# Safety Recall

Date	Number	Release	Page
12.2021	SC0433	01	1(9)

## Park Brake Control Valve MRU, TE

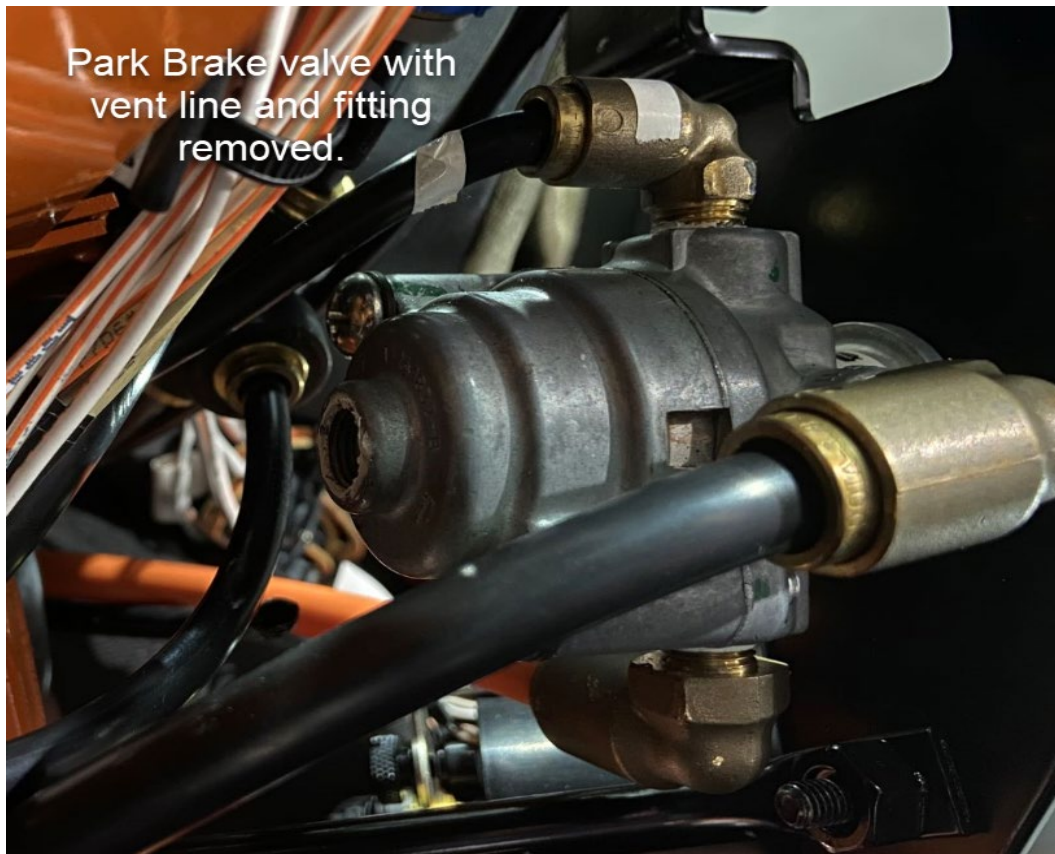
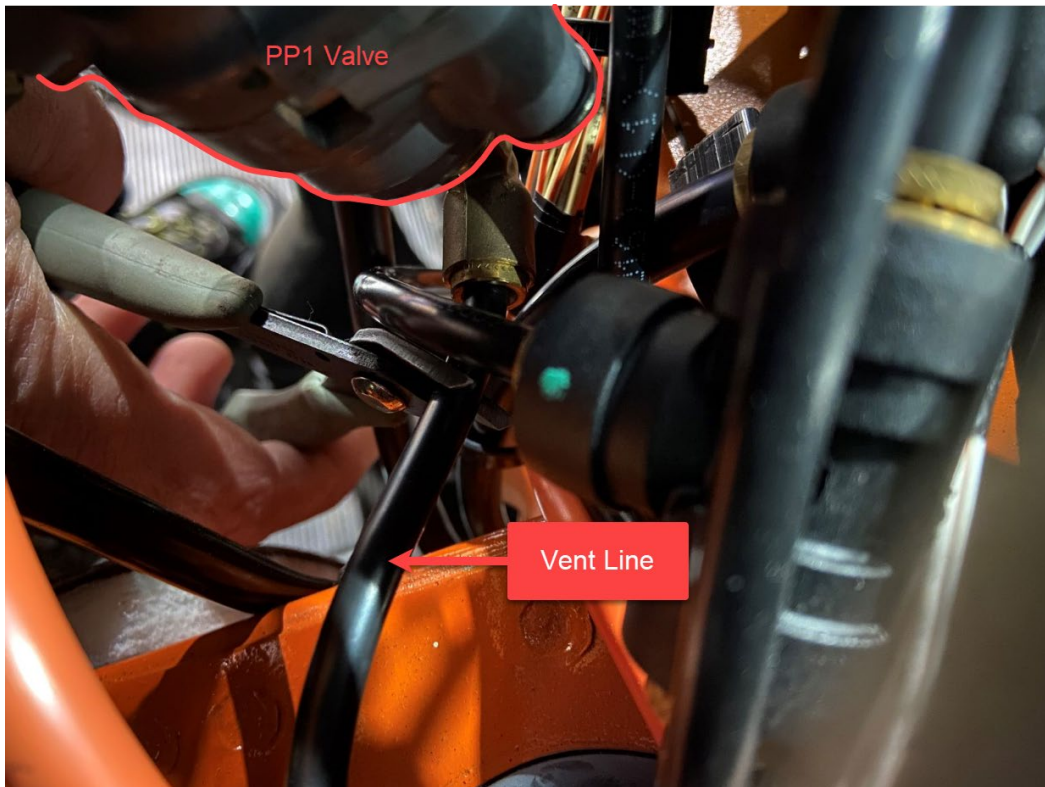
10. With all the panels removed, locate the park brake control valve (PP1) vent line. The vent line is directly opposite the yellow push pull button.

11. Cut the park brake control valve (PP1) vent line and remove the vent line fitting.

**NOTE:** The left behind vent line can be left in place with no consequence. With the vent line and fitting removed the venting air will be heard by the operator every time the park brake valve is cycled. The sound of venting air will need to be explained to the operator/owner as normal operation.
